DATE: January 14, 2015

AGENDA ITEM # 3

TO: Design Review Commission
FROM: Sean K. Gallegos, Assistant Planner
SUBJECT: 14-SC-35 – 643 Milverton Road

13-SC-35—643 Milverton Road

ATTACHMENT D

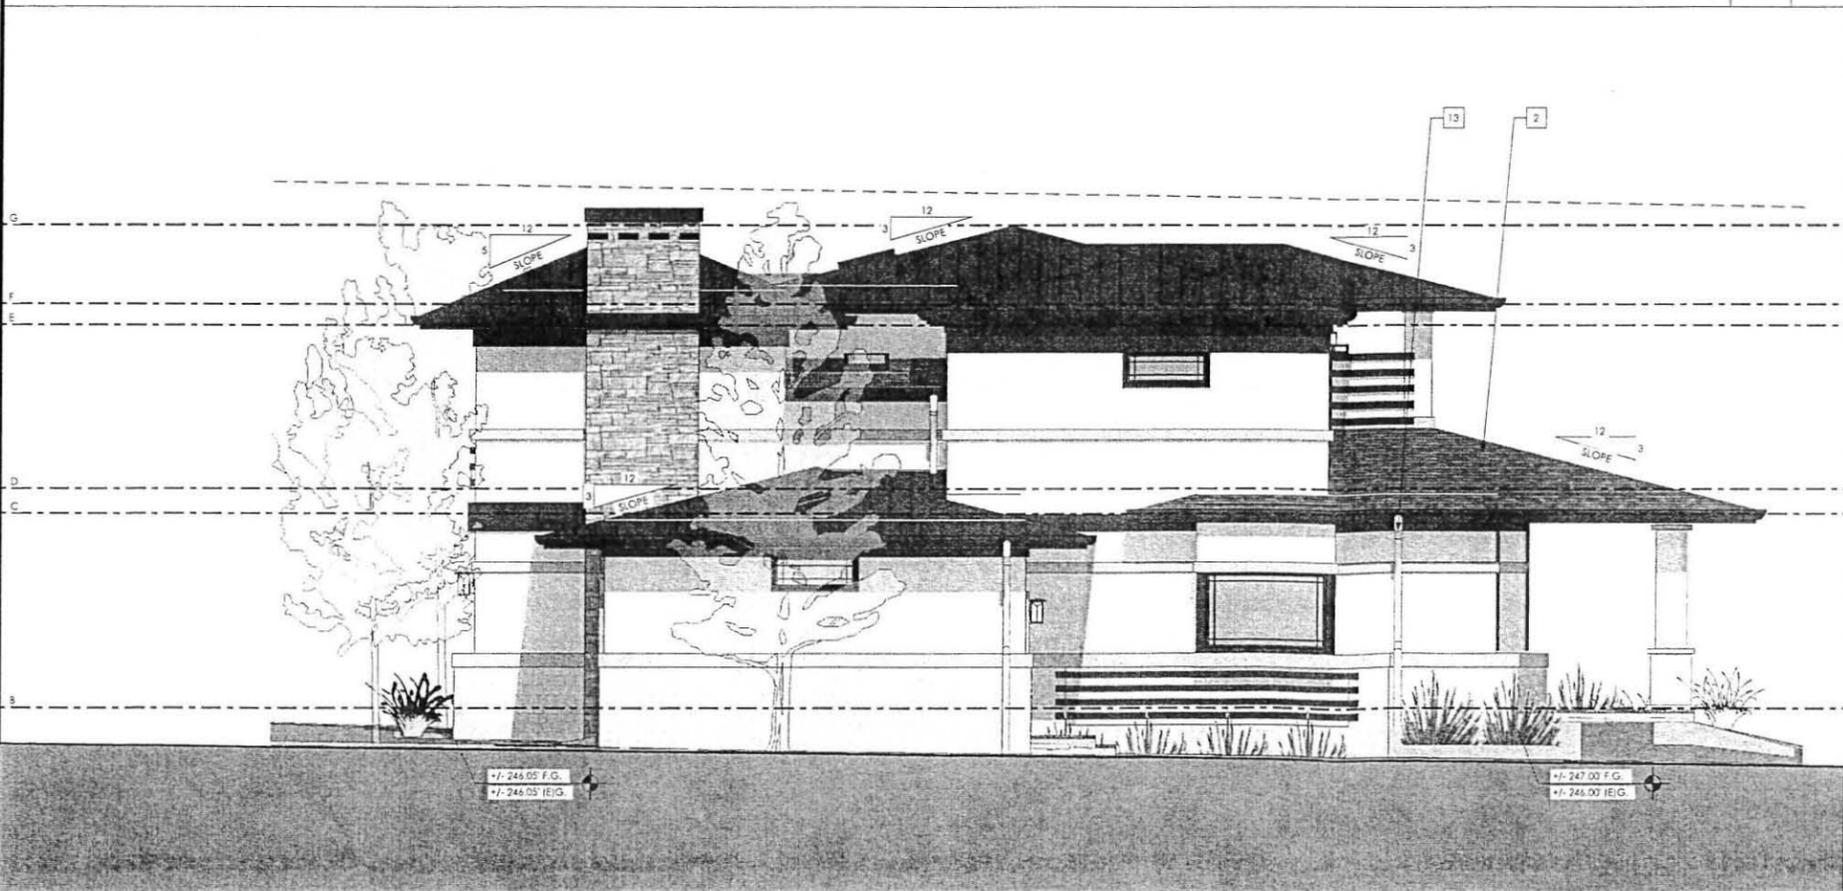
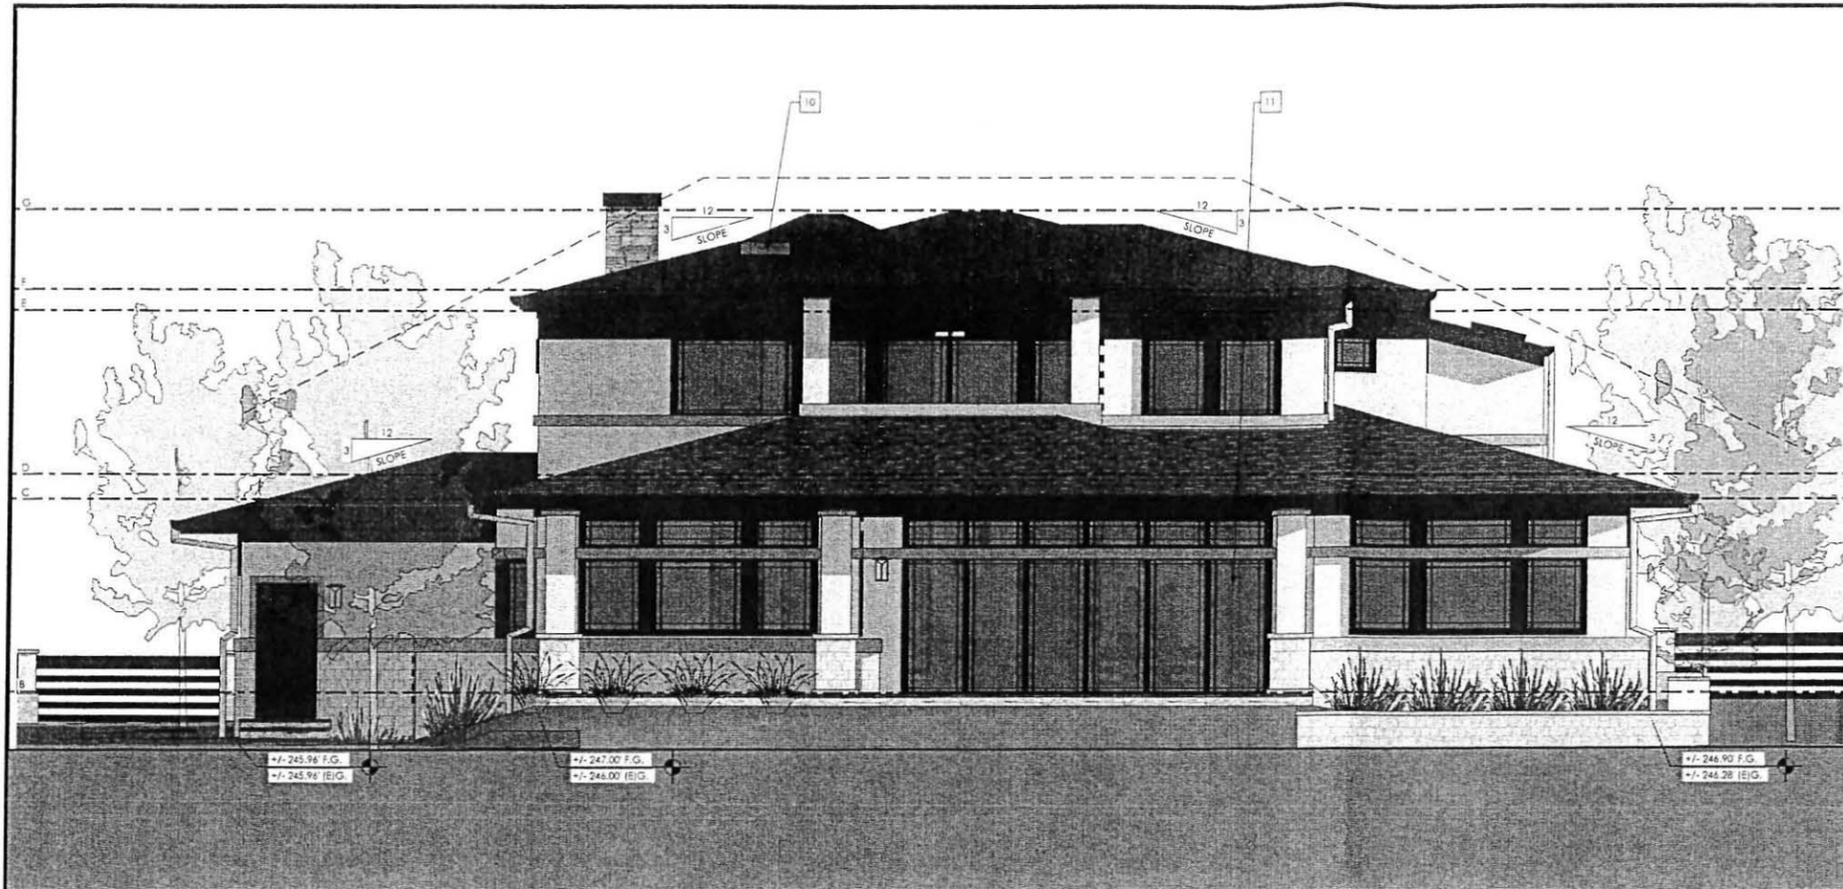
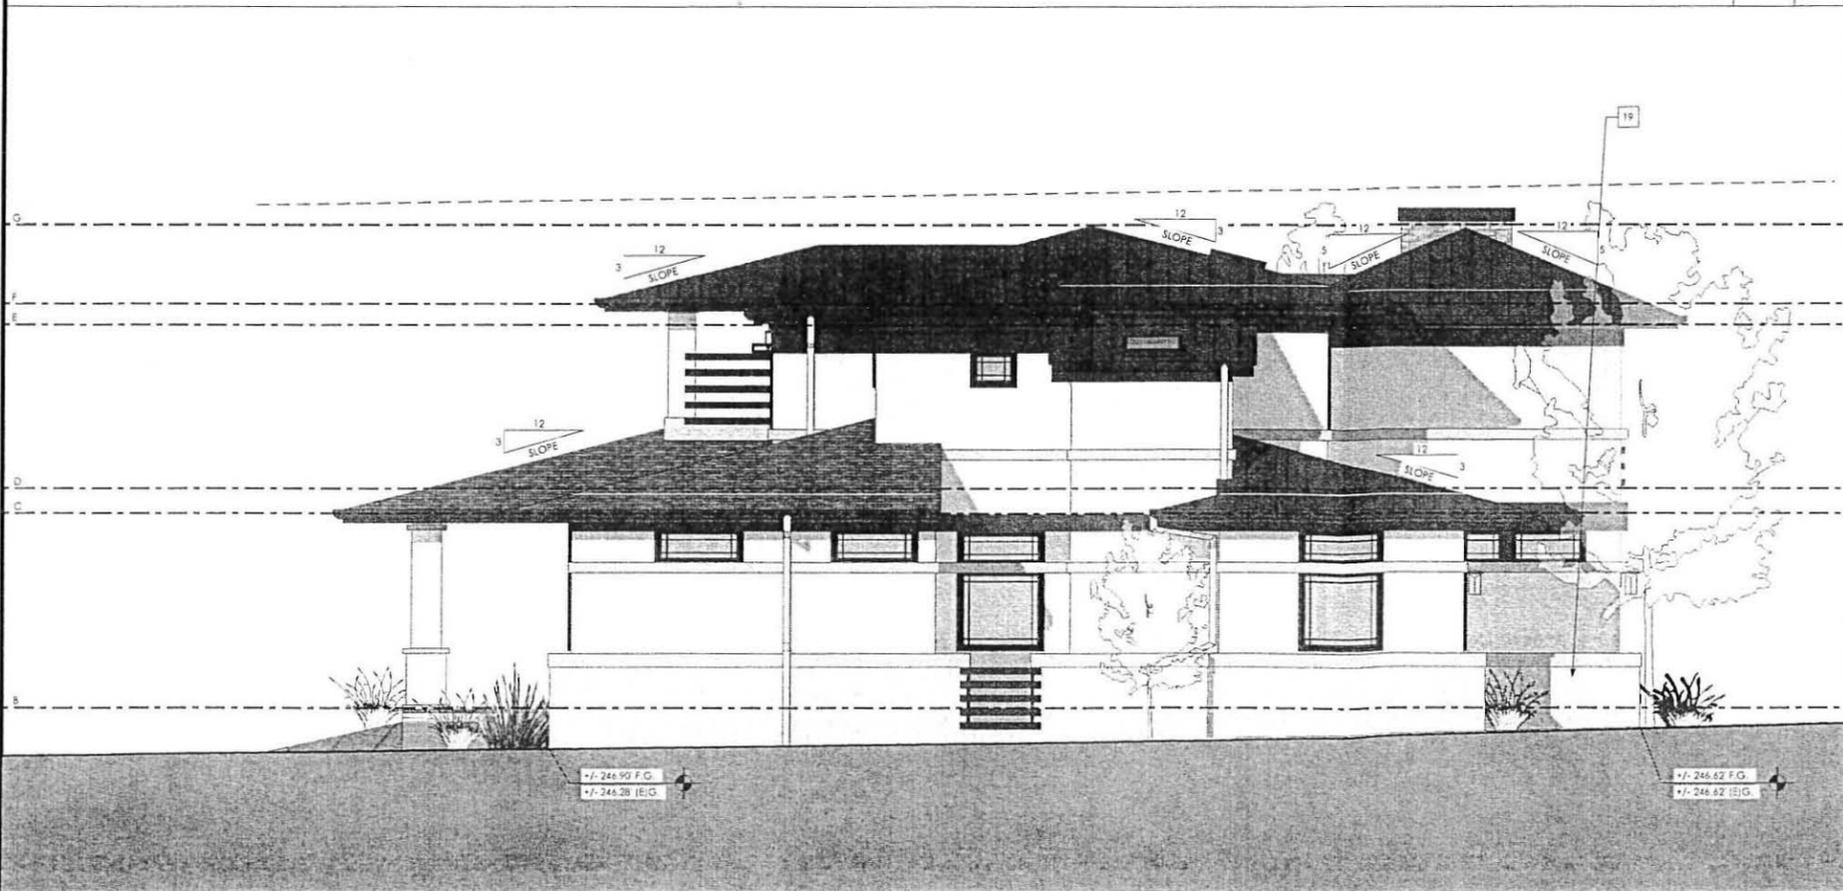
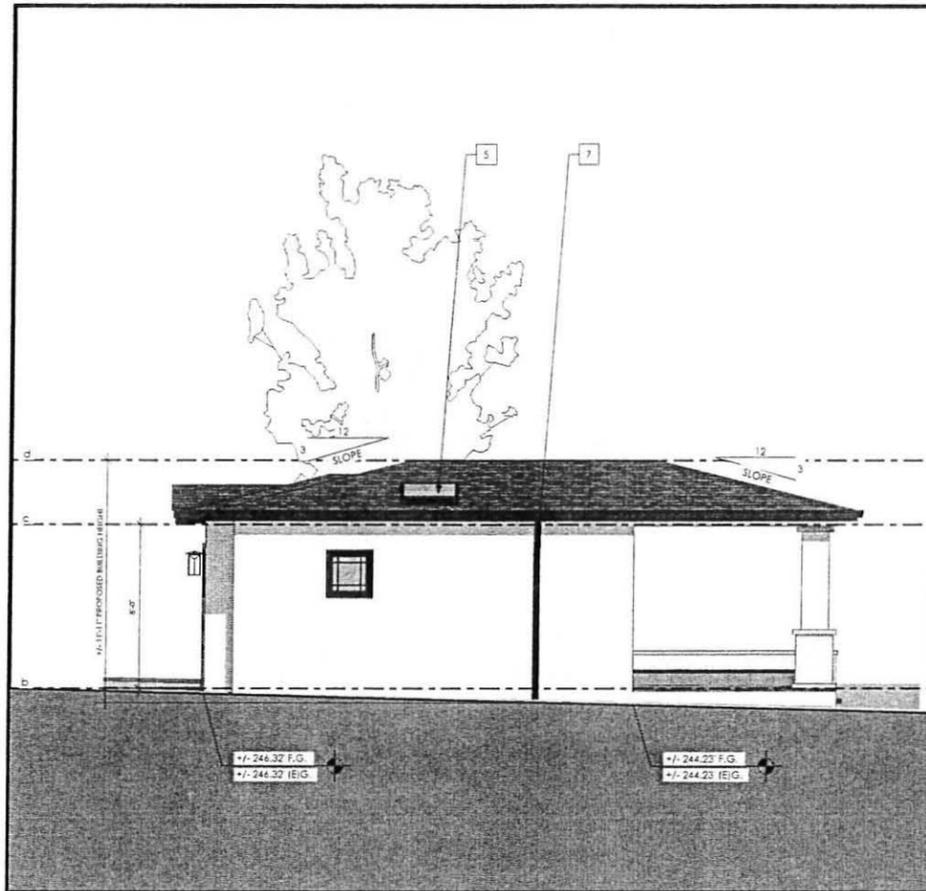
On November 5, 2014, the Design Review Commission held a public meeting to consider the proposed project. One neighbor spoke, raising concerns about house materials contributing to bulk and mass, and existing street flooding. The Commission expressed general support for the project but raised concerns about two-story element on the front, noting that it should be minimized. The Commission also noted that the balcony should have solid sides, the two roofing materials should not be mixed, it was acceptable to remove the Magnolia tree due to its condition, that circular driveways can benefit visibility by allowing cars to park off the street, and pervious pavers should be used for the circular driveway if it is maintained. Following the discussion, the Commission voted unanimously to continue the application and directed the applicant to address the following issues:

- Reduce the bulk and mass of the second story; and
- The removal of the magnolia tree is allowed; thus condition No. 4 should be omitted.

The commissioners discussed the project and expressed their general support for the design and made the following comments: the two-story element on the front should be minimized, the balcony should have solid sides, the drainage plan should be resolved, the setback of the drainage field should be increased, the two roofing materials should not be mixed, it was acceptable to remove the Magnolia tree due to its condition, that circular driveways can benefit visibility by allowing cars to park off the street, and pervious pavers should be used for the circular driveway if it is maintained.

In response to the Commission's action, the applicant made the following design revisions to the proposed house:

- The two-story element on the front was recessed from the first story to minimize the perception of bulk;
- The laundry room was relocated above the garage to permit the two-story element to be recessed from the first story. The modification resulted in an additional window along the right side for the laundry room with a sill height of five feet;
- The first-story roof on the right side was changed to simplify the hip forms;
- The first story and the cabana roof material was modified to a standing seam metal material to maintain a uniform roof material; and

- The privacy wall along the left and right side of the balcony is revised to show as solid wall with painted dark bronze wood trim for articulation.
- The circular driveway material was revised to permeable pavers.

The bulk of the structure has been reduced as viewed from the street with the two-story element being articulated and recessed from the first story and the roof form simplified along the right elevation. The addition of solid balcony screening walls diminishes privacy impacts along the side property lines. Therefore, the design revisions do appear to meet the intent of the Commission's direction to minimize the mass and bulk and privacy impacts of the second story.

PLAN VIEW

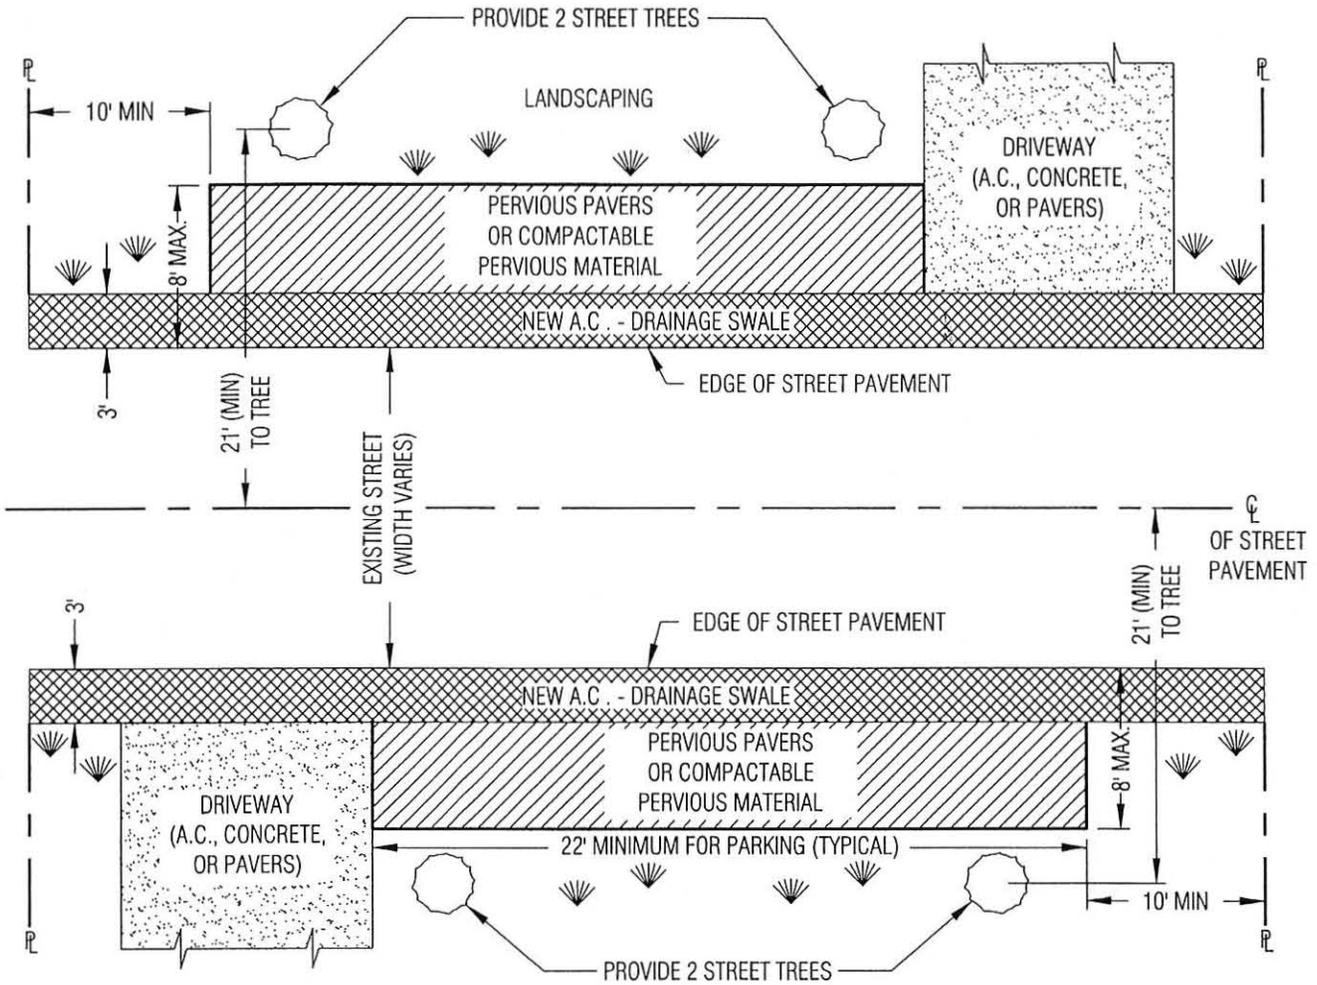
Landscaping drawing shows *Lomandra C* [little tuffy] planted in all of the Los Altos right-away shoulder between property line and pavement edge. This is in violation of code as described in Shoulder Paving Policy SU-20 and presents a safety problem in that pedestrians have no out of the way place to stand when cars pass them on our narrow street.
